**OFFICIAL COORDINATION REQUEST FOR
NON-ROUTINE OPERATIONS AND MAINTENANCE**

COORDINATION TITLE – 22 LGS 02 AWS Weir Crest Elevation During Navigation

COORDINATION DATE – 2815 April 2022

PROJECT – Little Goose Dam

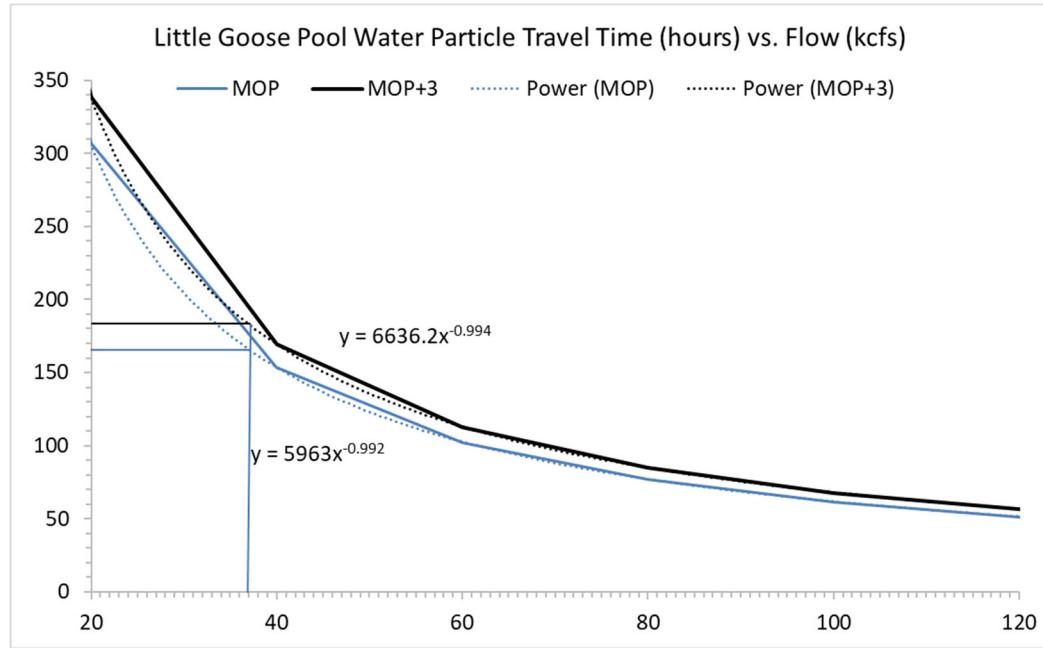
Raising the Little Goose pool to MOP+3 increases the pool volume and decreasing flow velocity, resulting in a decrease in water particle travel time, and thus potentially smolt travel time. Flows at Little Goose Dam averaged 36.9 kcfs during 14-27 April 2022, equating to estimated travel times of 165.9 hrs at MOP and 183.3 hrs at MOP+3, a difference of 17.4 hrs or a 10.5% increase in travel time (see Figure below).
